Display/Decode/Logic control PCB Pt No

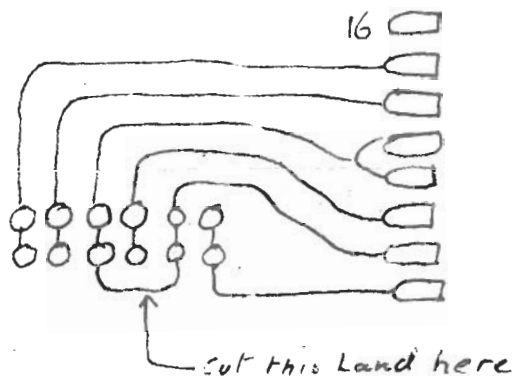
To eliminate the untidy scratched film and bulb polarity indicator specified in the original article we have adapted this PCB to use a 3015g tube. This is identical in appearance to the 3015f but has a plus, minus and one instead of the normal seven segment format of the 3015c. This tube is of course used in the 'thousands' digit position. A modification is required to the '9 to 16' sub-board for this digit only as shown below.

ON 3015G ONLY !!

The component marked 'opt 47uf' is a supply decoupling capacitor which has proved to be unnecessary and is not included in the kit.
